# FADU

## SGB Cabling, Inner Controller Ring

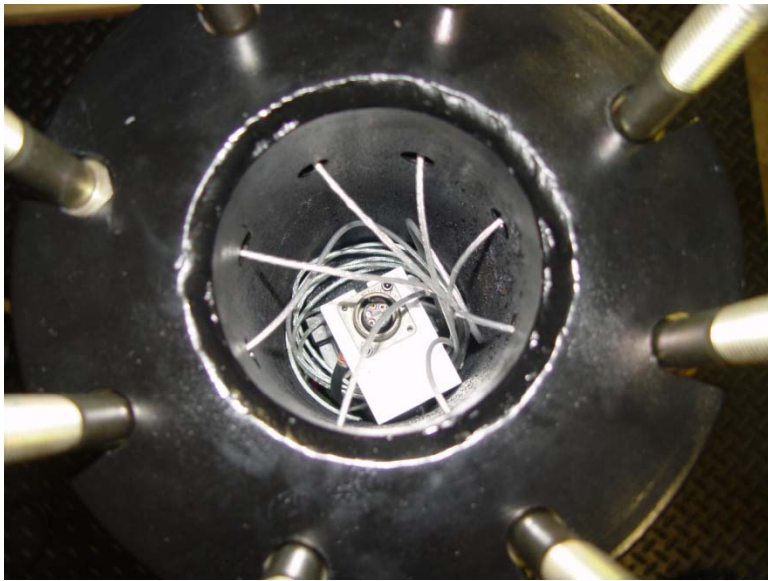
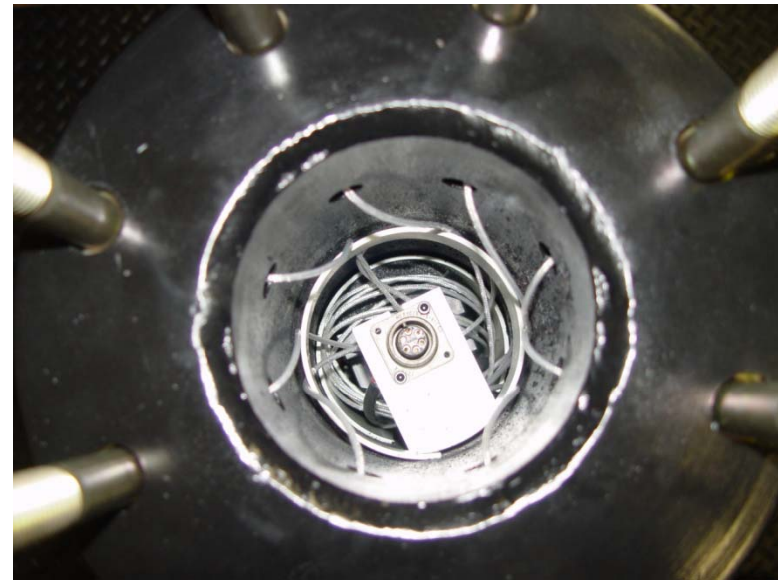
**WITHOUT Inner Controller Ring**  
Cables can interfere with access to the MIL-SPEC electrical connection when changing out various FADU modules.

**WITH Inner Controller Ring**  
Inner Controller Ring provides mechanism for neatly routing cables away from the MIL-SPEC electrical connection.
